FINAL - QUESTIONS + ANSWERS – Questions submitted through October 8, 2018

QUESTIONS + ANSWERS – Questions submitted through September 28, 2018

QUESTIONS + ANSWERS – Questions submitted through September 21, 2018

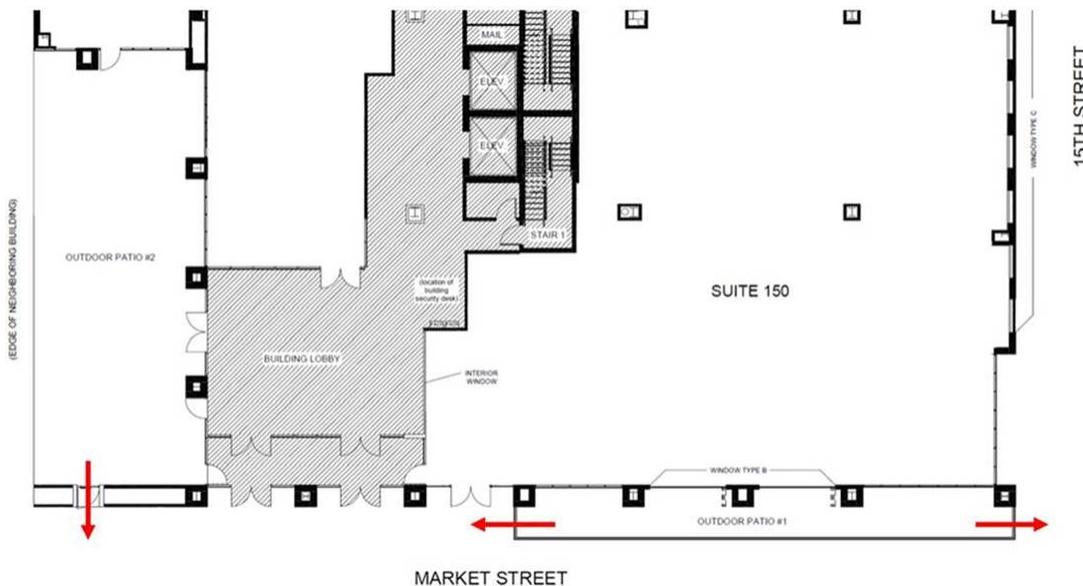
Q: Since no Brand Identity was supplied (either in brand story, logo, brand colors, etc.) we are assuming student may design the brand identity package for NEXT.

A: Each student is to develop their own brand identity for NEXT.
